Subject: **Bid No. 8819-M7 – Sprinkler & Fire Alarm Modifications – Union Station / WRA**

ADDENDUM NO. 3

SPRINKLER AND FIRE ALARM
MODIFICATIONS PHASE 2
UNION STATION
WORCESTER, MA

FA301

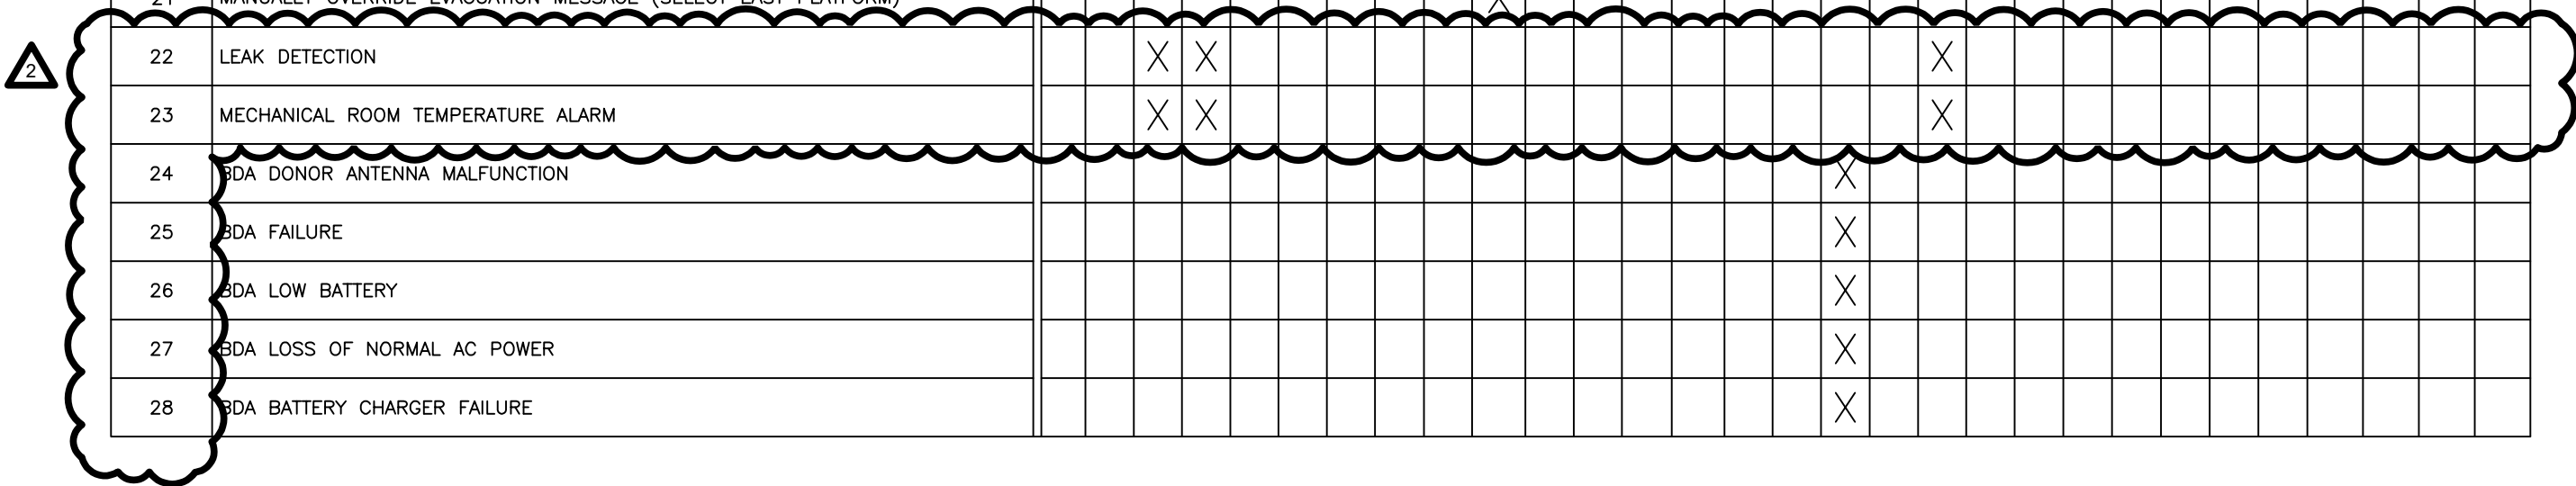
Drawing FA301, Electrical Fire Alarm Second Floor New Work Plan, Revise as follows:

- ADD leak detection controllers and temperature controller to I/O Matrix.

1 FIRE ALARM RISER DIAGRAM NOT TO SCALE

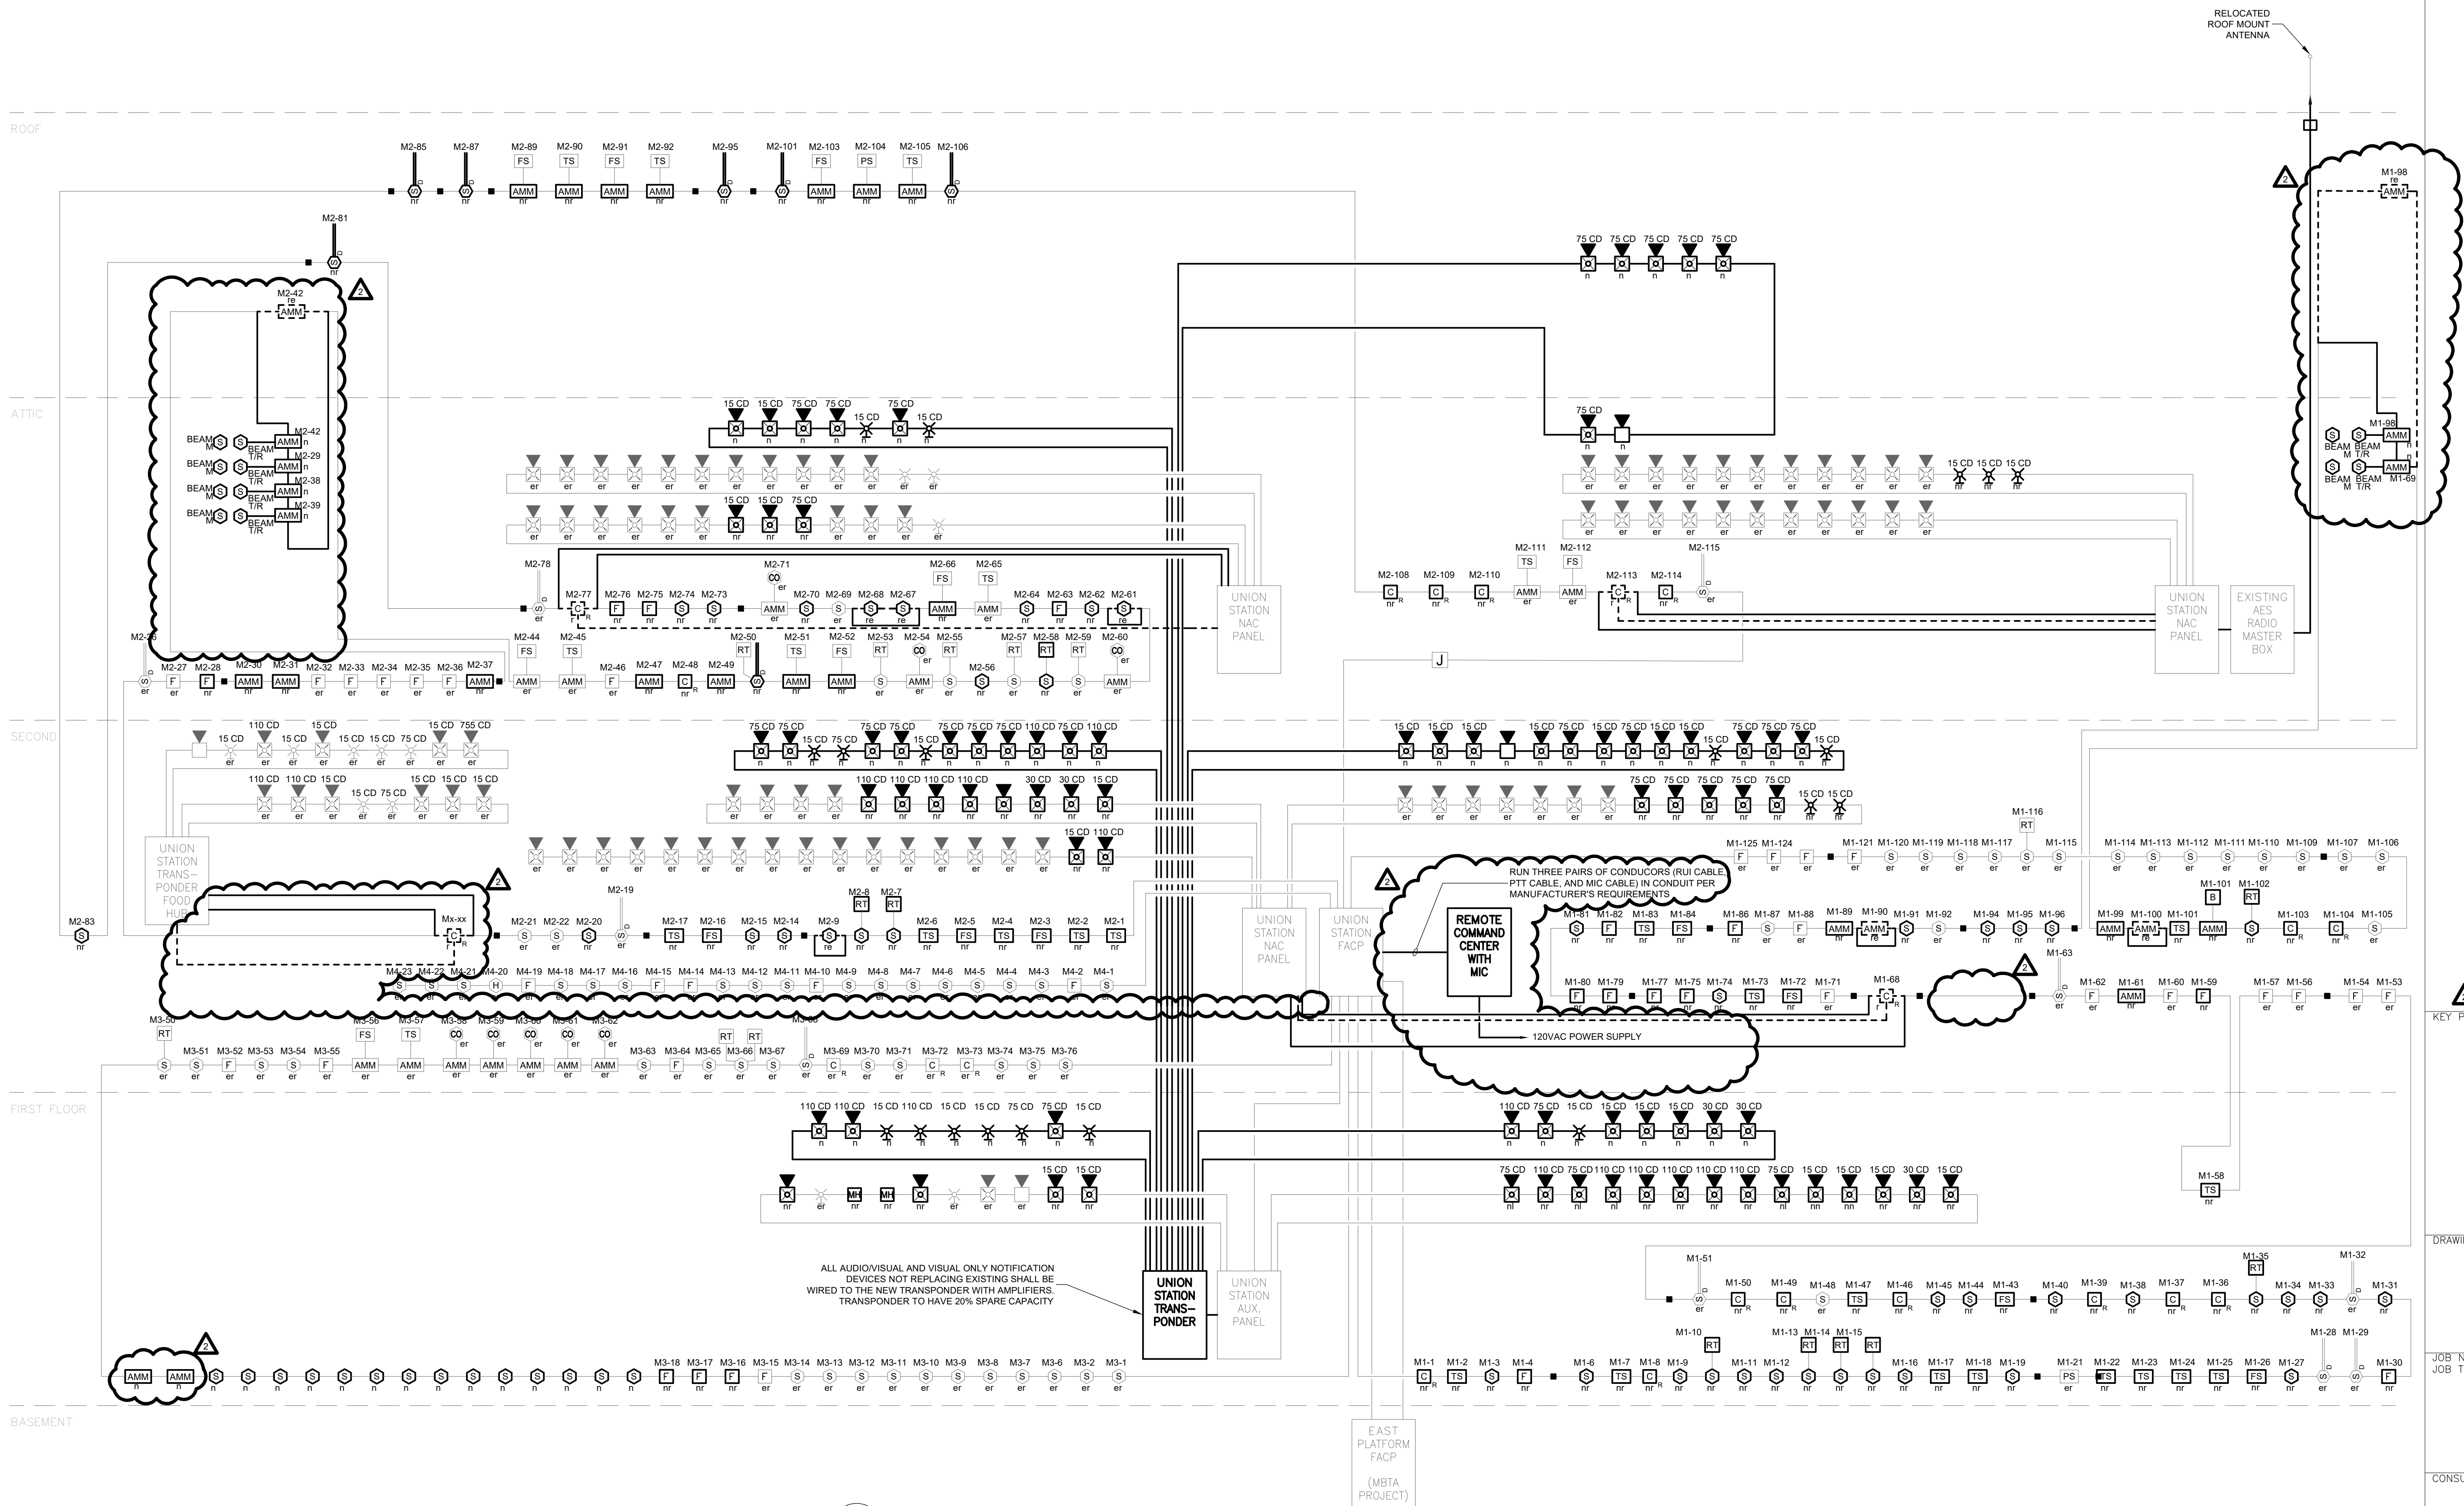
Drawing FA401, Electrical Fire Alarm Second Floor New Work Plan, Revise as follows:

- REVISED beam detectors from being “Existing to Remain” to “New to Replace Existing”.
- REVISE Addressable Monitor Module for Beam Detectors from “New to Replace Existing” to “Remove Existing”.
- REVISE wiring for new Remote Command Center from Fiber Optic Cable to copper cables.
- ADD 120V power supply for Remote Command Center.
- ADD a total of three addressable monitor modules for two leak detection controllers and temperature controller.
- ADD rewiring of NAC panel at Food Hub and demolition of associated control relay.
- DELETE addressable monitor modules with address point M1-65 and M1-66.

Q: Riser Diagram for 1st Floor, left-hand side shows 13 new NAC devices in total. (1) 75CD speaker/strobe and (1) 110CD speaker/strobe cannot be found on the floor plan.

Q: Riser Diagram for 1st Floor, right-hand side shows 15 new NAC devices in total. (1) 15 CD speaker/strobe and (1) 15CD strobe cannot be found on the floor plan.

Q: Riser Diagram for 2nd Floor, left-hand side shows 7 new NAC devices in total. (2) 75 CD speaker/strobes cannot be found on the floor plan.

A: Delete (1) 75CD speaker/strobe and (1) 110CD speaker/strobe from the riser.

A: Delete (1) 15CD speaker/strobe and (1) 15CD strobe from the riser.

A: Revise (1) 75CD speaker/strobe to be 15CD speaker/strobe on the riser and Delete (1) 75CD speaker/strobe.
